AUTOMATIC TRANSMISSION SERVICE GROUP

"VOLUME II"

INTRODUCTION

Since the introduction of the THM 440-T4 (4T60) Transaxle in April, 1984, there have been MANY major engineering design changes. These changes have affected nearly every part used in the THM 440-T4 (4T60).

Figure 33

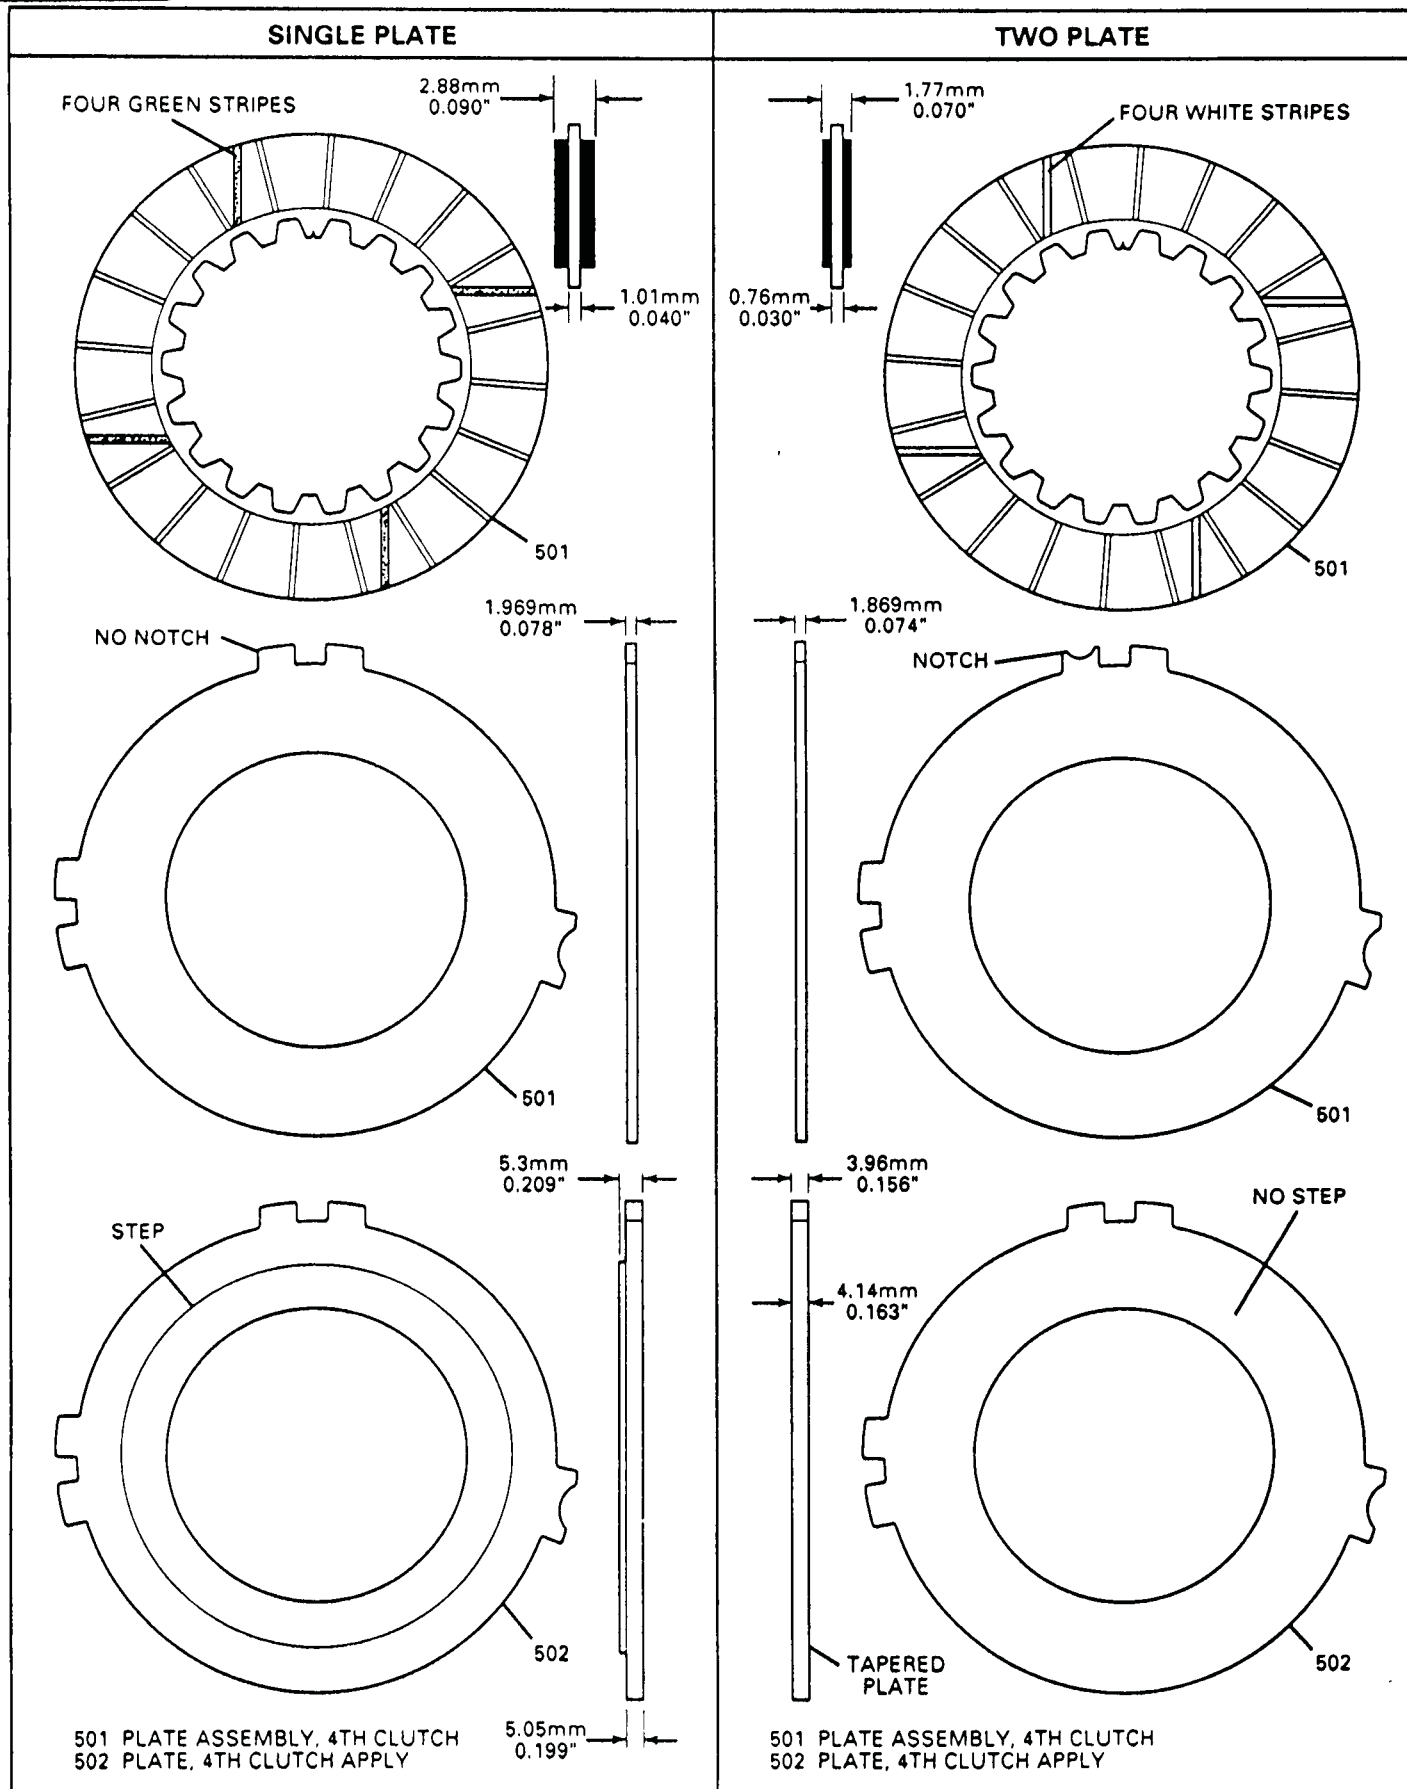
CHANGE: A new "Two Plate" 4th clutch assembly was used to replace the Single Plate 4th clutch assembly for SOME MODELS ONLY on the 1990 THM 440-T4 transaxles (See Figure 33).

- (1) 4TH CLUTCH LINED PLATES - Were made thinner by .020" than the previous lined plate, and can be identified by the four WHITE stripes, while the single plate lined plate has four GREEN stripes (See Figure 33). The Single Plate 4th Clutch is .090" thick, and the new "Two Plate" 4th Clutch plates are .070" thick.
- (2) 4TH CLUTCH STEEL PLATES - Were made thinner by .004" than the previous plates, and can be identified by a "Notch" cut into one of the tabs (See Figure 33). The single plate 4th clutch steels are .078" thick, and the new "Two Plate" steels are .074" thick.
- (3) 4TH CLUTCH APPLY PLATE - Was machined thinner than the previous apply plate, and the step was removed. Refer to Figure 33.

Figure 35

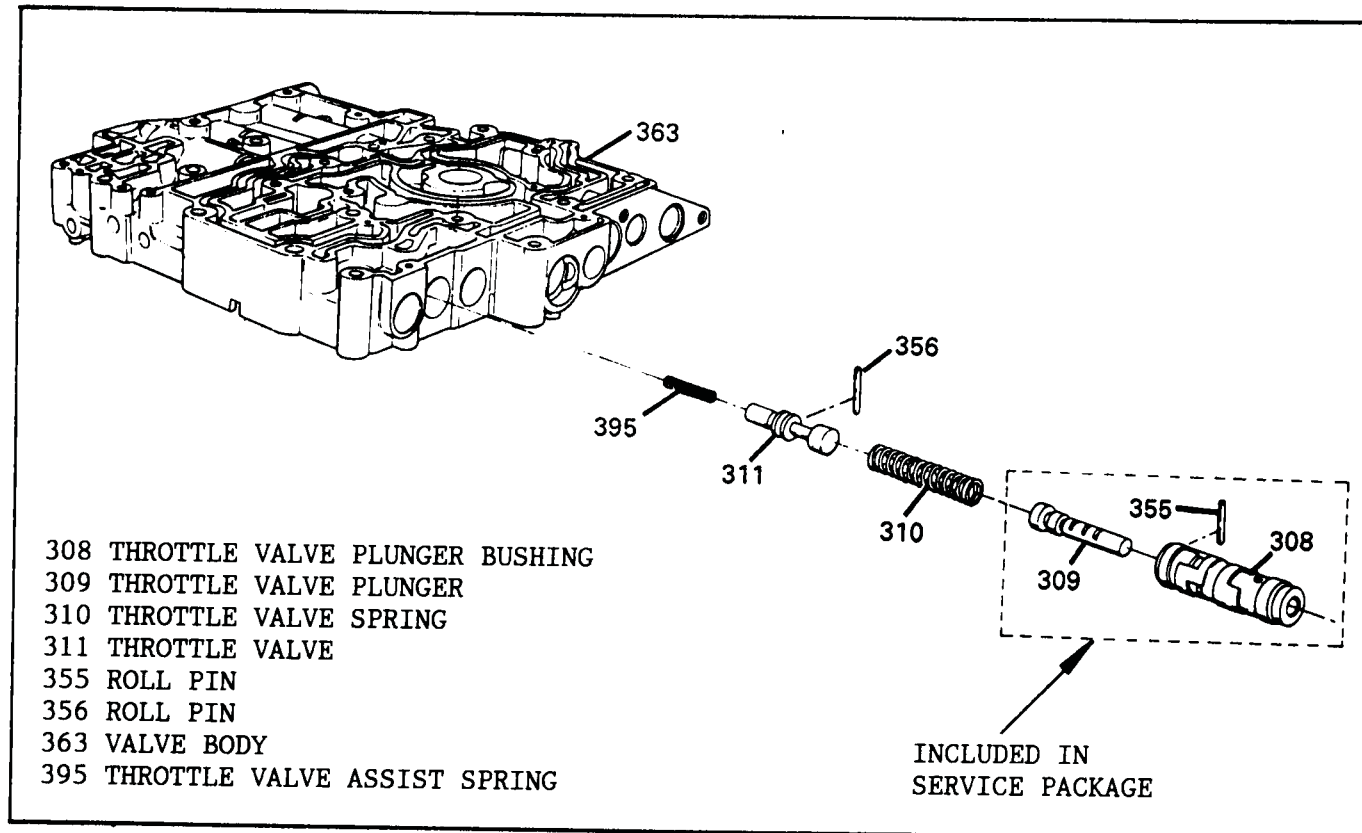
The T.V. Plunger and Bushing Assembly are now available from OEM in a service package, so that buying a valve body is no longer necessary when the TV plunger is broken or cracked (See Figure 35). Refer to the following OEM part numbers as it IS a model sensitive part.

Figure 36

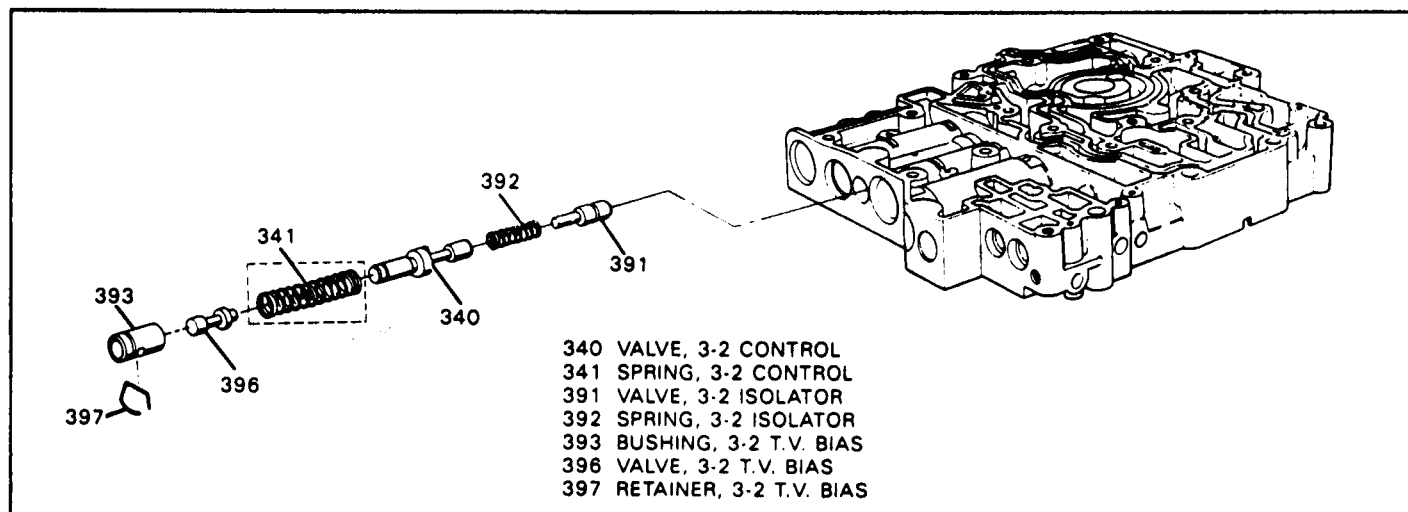
COMPLAINT: Harsh 3-2 part throttle, and/or full throttle downshifts.

CAUSE: Improper timing for release of the third clutch and reapplication of the 1-2 band.

CORRECTION: Install a new 3-2 Control Valve Spring, now available in a service package from OEM. See "Service Information" on pages 43 and 44 for proper OEM part numbers. Refer to Figure 36 for proper installation. This IS a model sensitive part.

Figure 37

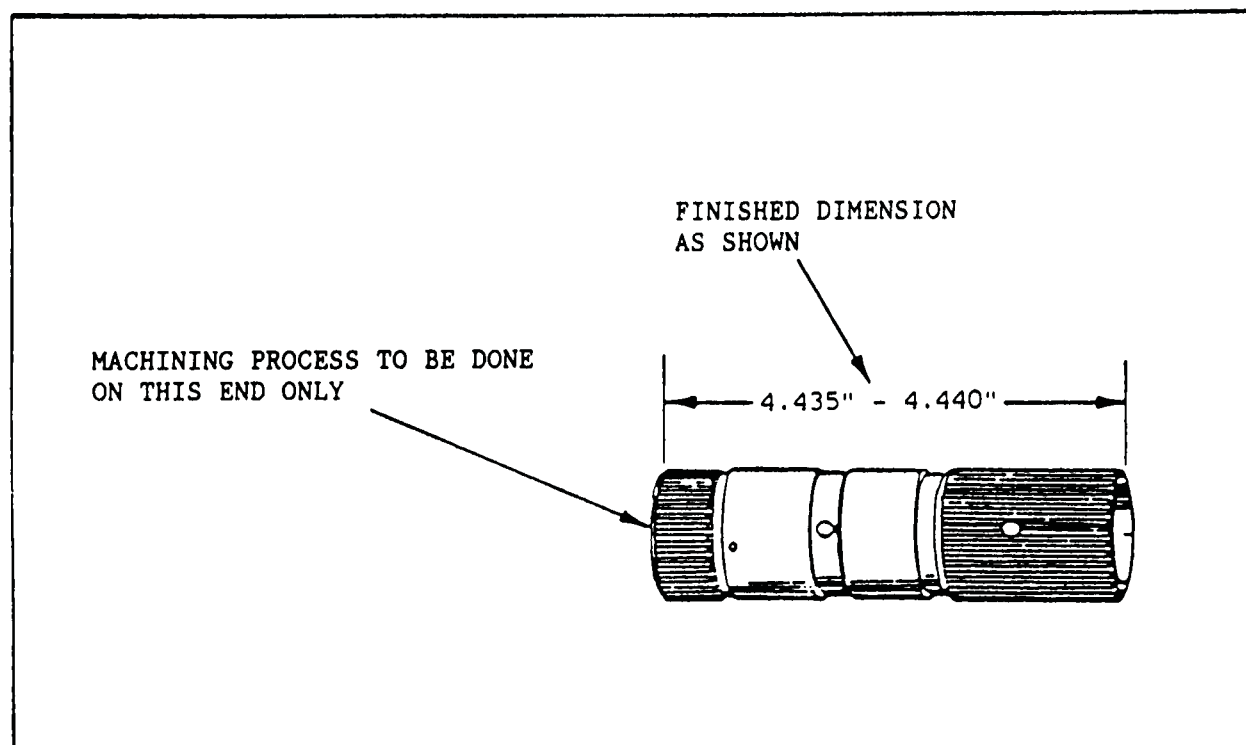
COMPLAINT: Plastic Lube Dam located between the carriers, in two pieces, appearing as if it had been machined. Sometimes not machined all the way through.

CAUSE: Final drive sun gear shaft is too long, and cuts or machines plastic lube dam in half.

CORRECTION: Machine or grind the final drive sun gear shaft, ON THE SHORT SPLINED END ONLY, to the dimension shown in Figure 37. Finished dimension should be 4.435" - 4.440". Non-machined final drive sun gear shaft will measure 4.480" - 4.490".

Figure 39

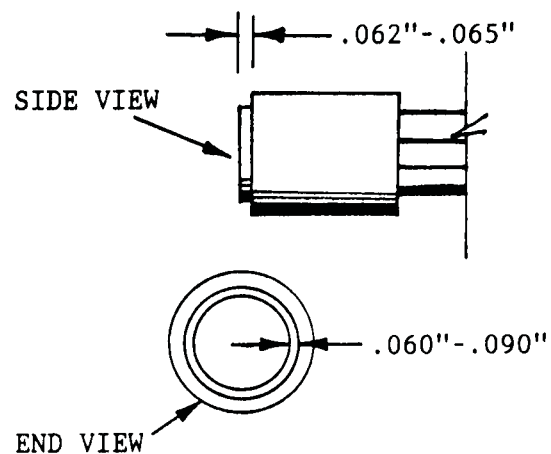
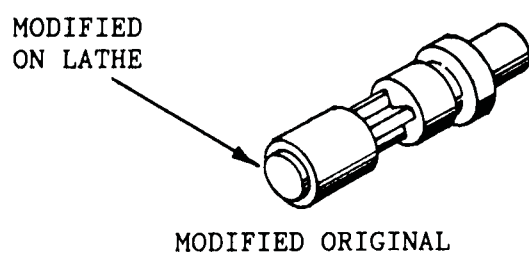
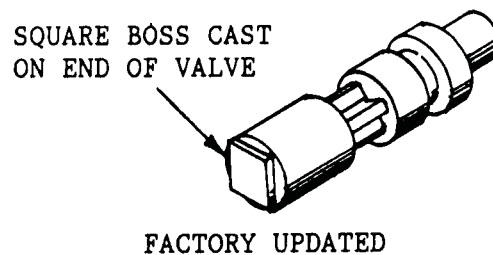
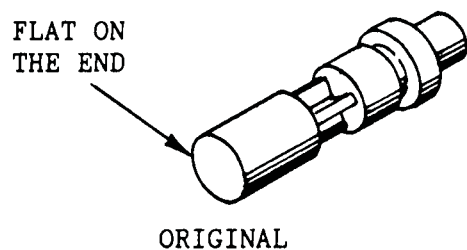
CAUSE: The cause may be the 1-2 shift valve sticking in the upshifted position (See Figure 38). The 1-2 shift valve is aluminum and might have a tendency to "Mushroom", caused by hitting the valve body casting in the bottom of the bore.

CORRECTION: Modify the original 1-2 shift valve as shown in Figure 39. This is a very simple machining operation on a lathe. The factory has upgraded the 1-2 shift valve with a "Boss" cast on the end of the valve (See Figure 39).

THIS MODIFICATION KEEPS THE END OF THE SHIFT VALVE FROM "FLARING OUT" WHEN IT BOTTOMS IN THE BORE.

Figure 40

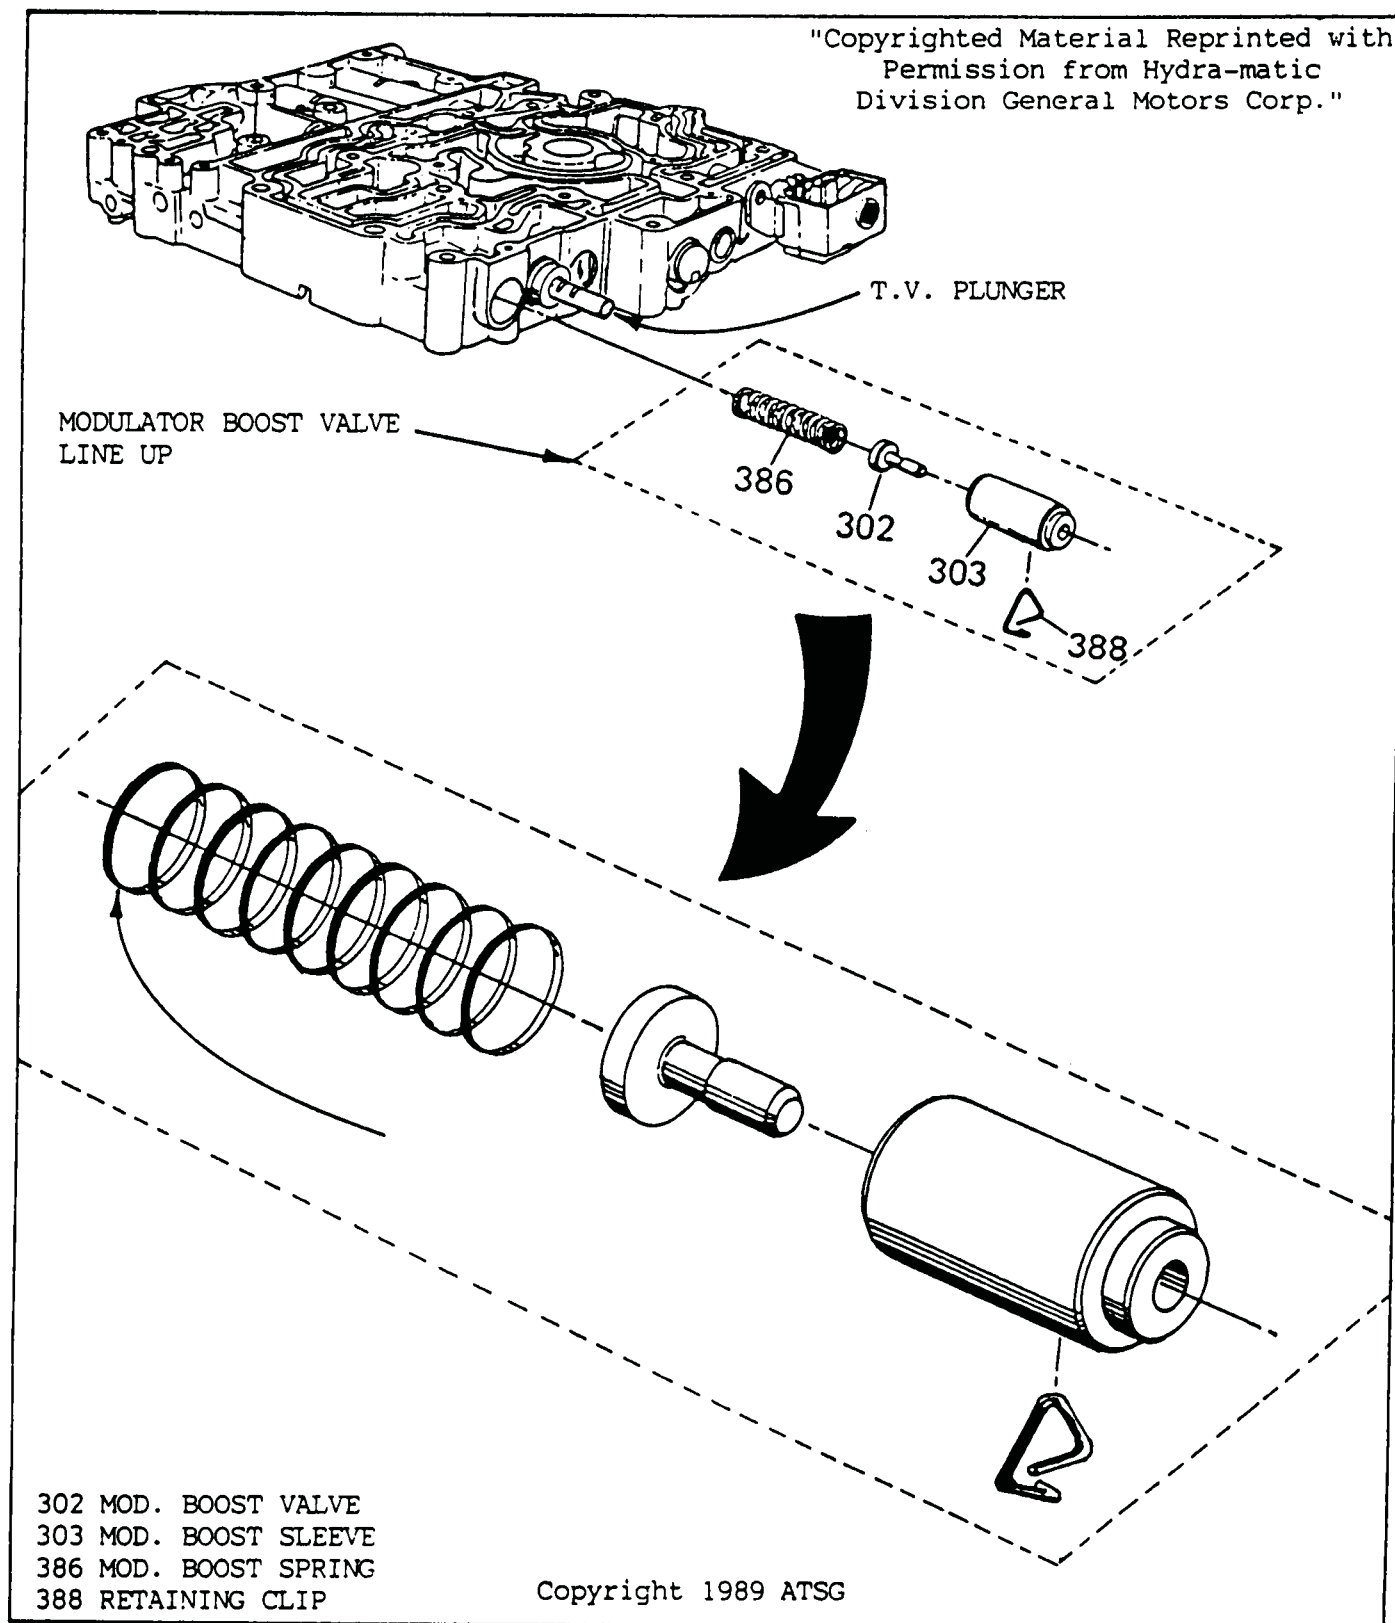
COMPLAINT: 2nd clutch pack with a very short life span, usually associated with a 1-2 slip, or a 1-2 slide bump.

CAUSE: The cause may be a lack of line pressure rise to sufficiently apply the second clutch pack. We also recommend OEM "Koline" steel plates in this pack, and "Vespel" sealing rings on the driven sprocket support.

CORRECTION: Shorten the modulator boost valve spring by 1/4" or approximately 1 to 1 1/2 coils. The modulator boost valve spring is located in the pressure regulator line-up, which is directly next to the T.V. plunger in the valve body (See Figure 40). This will allow line pressure to rise at less of a throttle opening and greatly increase 2nd clutch durability. This modification should be done on "ALL" THM 440-T4 transaxles during the rebuilding process.

Figure 41

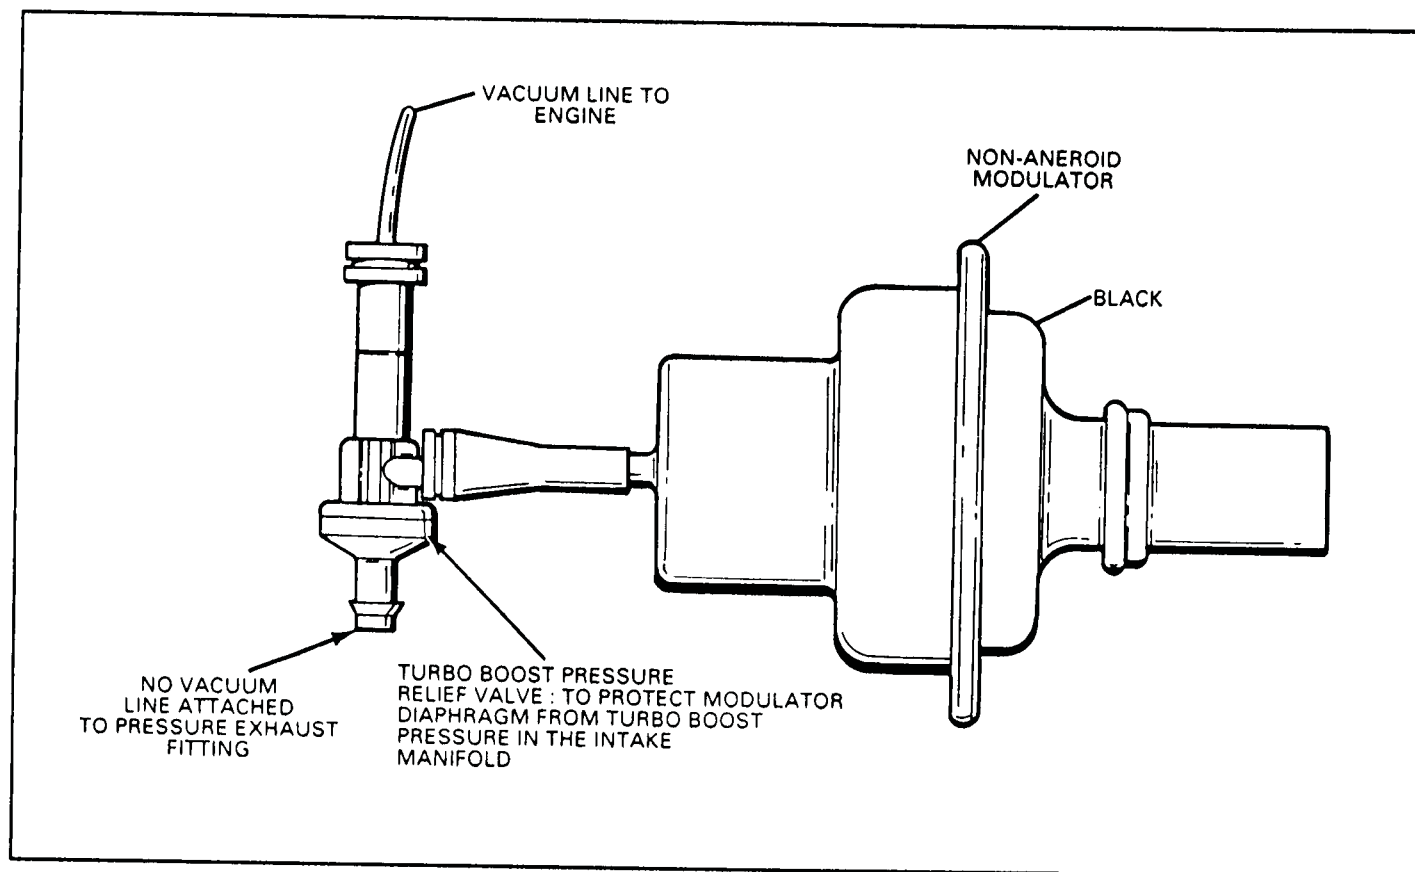
CHANGE: There is now a new Vacuum Modulator, with a Pressure Relief Valve installed between the modulator and the vacuum line to the engine. (See Figure 41).

- (1) VACUUM MODULATOR - Special non-aneroid modulator that is compatible with the 3.1L Turbocharged Engine ONLY. The transmission model codes are OLAH, and OYRH, and found in the "W" car.
- (2) PRESSURE RELIEF VALVE - To protect the diaphragm in the modulator from turbo boost pressure in the intake manifold. This is a "One-Way" valve and must be installed as shown in Figure 41.
